Sundry Print Report

Well Name: RDX FEDERAL 17 Well Location: T26S / R30E / SEC 17 / County or Parish/State: EDDY /

Sundry ID: 2674247

Type of Action: Plug and Abandonment

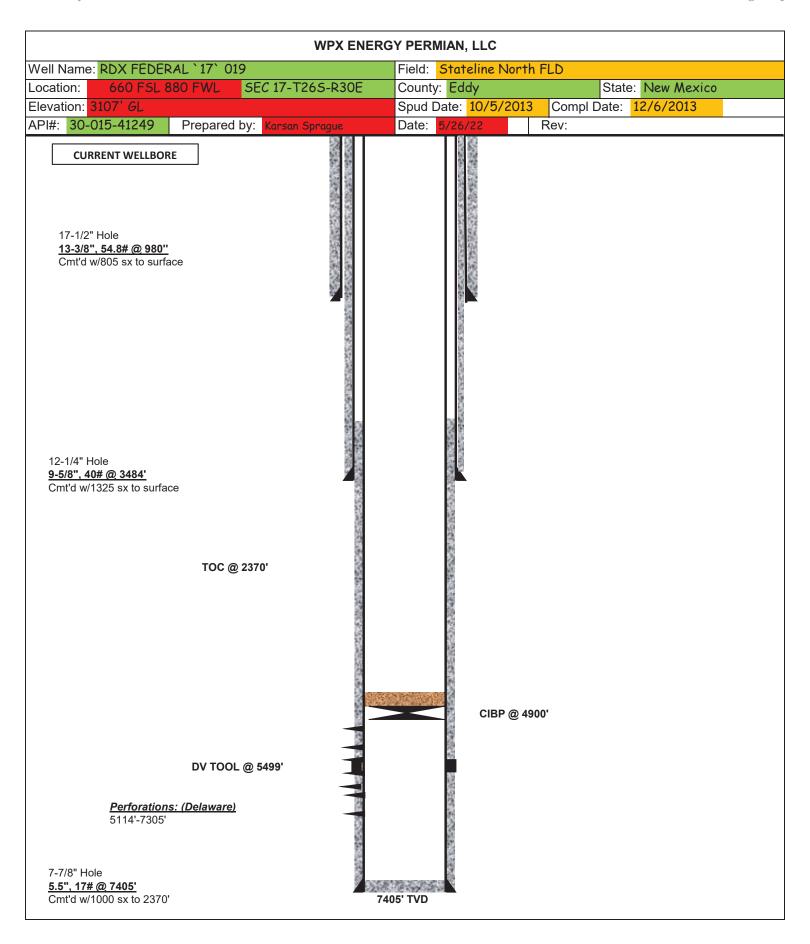
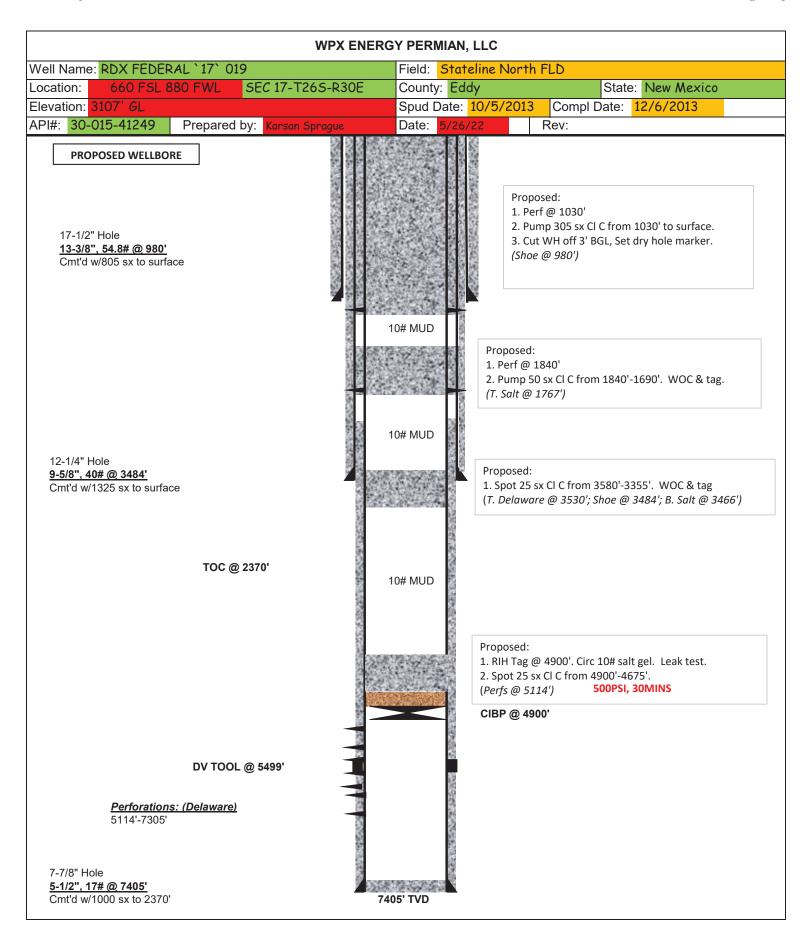
BLM Note: Plugs OK as pro	posed. Leak test: 500p	osi, 30mins				
		KEIT	TH IMMA		by KEITH IMMATTY 2 16:20:00 -06'00'	
14. I hereby certify that the foregoing is to Name (Printed/Typed) KARSAN SPRAGUE	true and correct.	Title F	Production Engine	eer		
Signature Karsan S	Sprague	Date	05/26/2022			
	THIS SPACE	FOR FEDERAL (OR STATE O	FFICE USE
